City of Portland, Maine - Building or Use Permit Application 389 Congress Street, 04101, Tel: (207) 874-8703, FAX: 874-8716

Location of Construction: 32 Porch St		Owner: Phyllis W. Wilkins		Phone: 878-2276		Permit No: 981319	
Owner Address: 32 Porch St Portland ME		Lessee/Buyer's Name:		Phone:		BusinessName:	
Contractor Name: Peter B. Rice & Co., Inc.		Address: 94 Webster Rd Freeport 04032		Phone: 865-4061***		Permit Issued: NOV 23 1998	
Past Use: 1-family		Proposed Use: same/finished basement		COST OF WORK: \$ 22,500		PERMIT FEE: \$ 135.00	
				FIRE DEPT. <input type="checkbox"/> Approved <input type="checkbox"/> Denied		INSPECTION: Use Group: Type:	
Proposed Project Description: Finish portion of basement and over garage		Signature:		Signature:		Zone: CBL: 376 R-3 (R) S-1-A-026	
		PEDESTRIAN ACTIVITIES DISTRICT (P.A.D.)		Action: Approved <input type="checkbox"/> Approved with Conditions: <input type="checkbox"/> Denied <input type="checkbox"/>		Zoning Approval: Special Zone or Reviews: <input type="checkbox"/> Shoreland <input type="checkbox"/> Wetland <input type="checkbox"/> Flood Zone <input type="checkbox"/> Subdivision <input type="checkbox"/> Site Plan maj <input type="che

Wilkins Residence
 Finished Basement Space

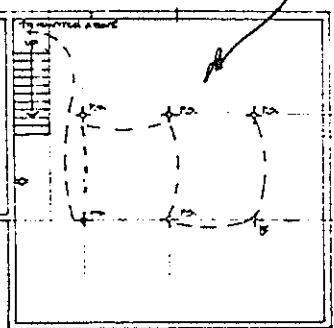
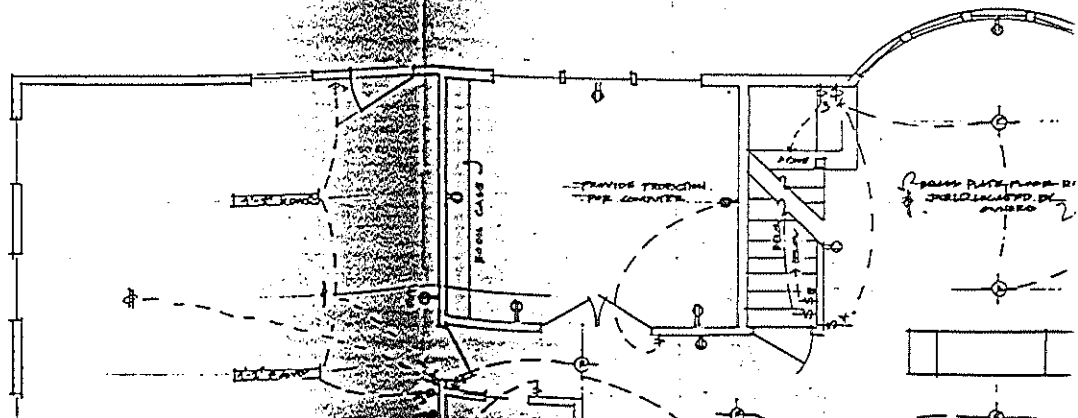
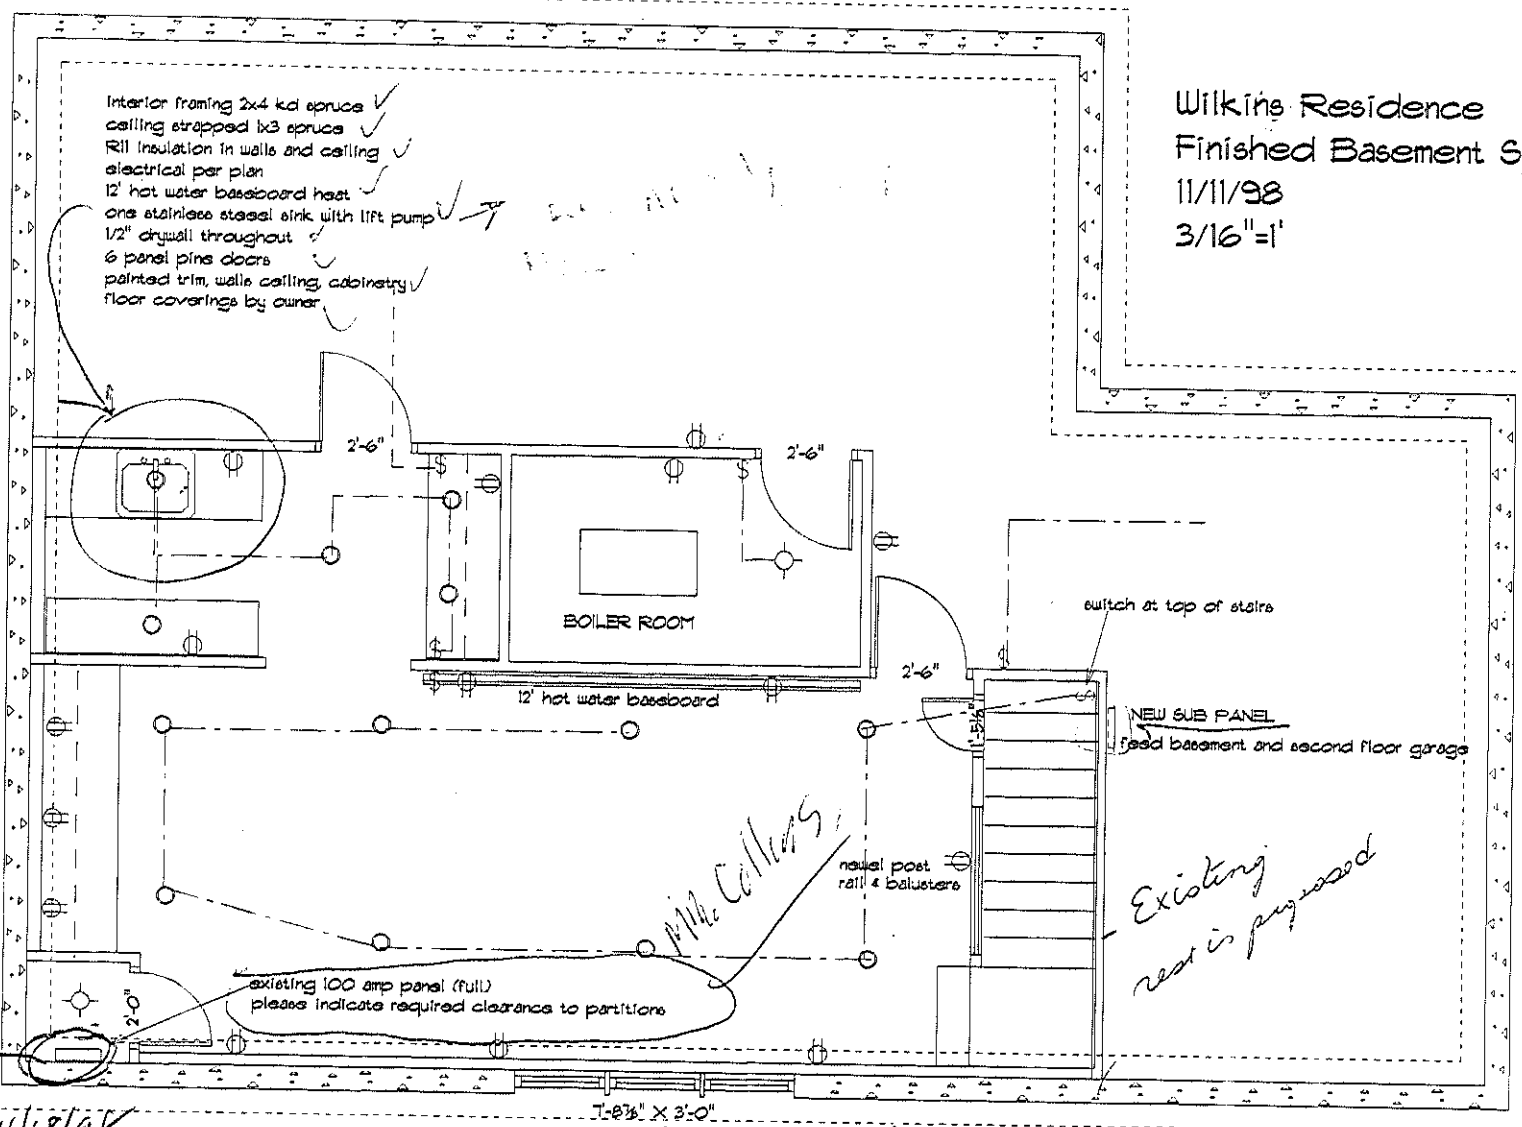
11/18/98
 (30" IN FRONT OF PANEL (WIDTH)
 (36" DEEP TO FAN 865-0161
OPPOSITE WALL)
